Docket Number:	15-AFC-02
Project Title:	Mission Rock Energy Center
TN #:	216060
Document Title:	Nina Danza Comments: Erosion Protection Planned at SCR- 1 and Application to MREC
Description:	N/A
Filer:	System
Organization:	Nina Danza
Submitter Role:	Public
Submission Date:	2/15/2017 10:00:00 PM
Docketed Date:	2/16/2017

Erosion Protection Planned at SCR-1 and Application to MREC

Figure 4.1 – Typical Cross Section of Alternative 1, Soil Cement for Design Flow (Sta. 270+00)

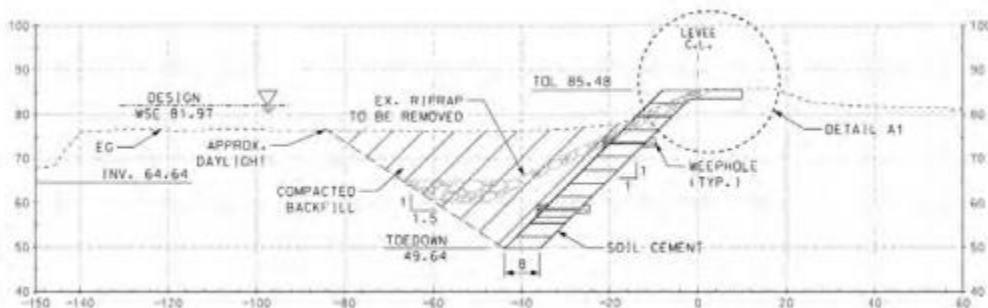
A 2015 design study prepared by TetraTech for VCWPD concluded the preferred alternative for levee protection to be 'Alternative 1 – an 8-foot-wide section of soil cement with a slope of 1H:1V' as shown in the figure below. The TetraTech study computed hydraulic flow and velocities using the Hydrologic Engineering Center—River Analysis System (HEC-RAS), Version 4.1.0 (ACOE 2010a) program. TetraTech also performed sediment transport analysis for the erosion protection concept design.

Key features of the preferred alternative include: an 8' thickness soil cement facing, total height of levee pavement 35' (approx.), 30' soil backfill against levee, with 15' pavement depth below existing river invert.

Though differences between this location and the MREC location exist, for example: (a) the SCR-1 levee is under ACOE jurisdiction and their regulatory standards whereas the proposed MREC fill may

not be; (b) SCR-1 is subject to ACOE design standards which prohibit vegetation on levees whereas MREC fill is not, the essential need for erosion protection is the same for both projects.

The projects are not far apart in distance. Knowing the planned erosion protection at SCR-1, a similar preliminary concept for erosion protection of fill at MREC should be based on answers asked by CEC such as:

1. Has hydraulic modeling been performed to determine flood flow characteristics eg depth and velocity such as that done for SCR-1?
2. Has modeling been performed to determine projected erosion at the fill toe?
3. Has sediment transport been modeled and incorporated into the erosion protection concept?
4. What are the special characteristics of flow at this location (vector direction and force)?
5. Are vegetation and fiber rolls adequate for erosion protection at MREC based on information at other locations and provided by the above questions?
